Service Information no. 190

Chameleon automatic Satellites changes to improve the change over system

This Service information covers the following equipment: All SA Satellites!

Mechanical change

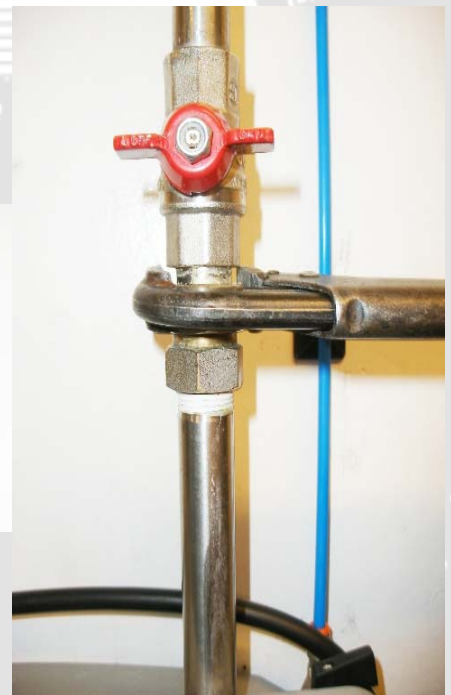
- The first change is that we have introduced a water limiting nozzle, which will allow “only” 50 L/min at 20-25 bar to pass through the Satellite. This will ensure that the change over function will be more stable. The nozzle will remove the problem to get the system to change from rinse to foam.

- Close water supply, disconnect the water pipe at the union
- Mount the flow limitation nozzle inside the union (the nozzle must be pressed or gently hammered until it's fixed)
- Re-mount pipe union and test

Sensor check

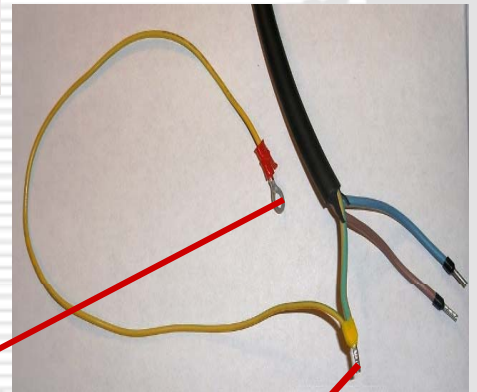
- Check sensor version
- If sensors are of the old version, sensor must be changed
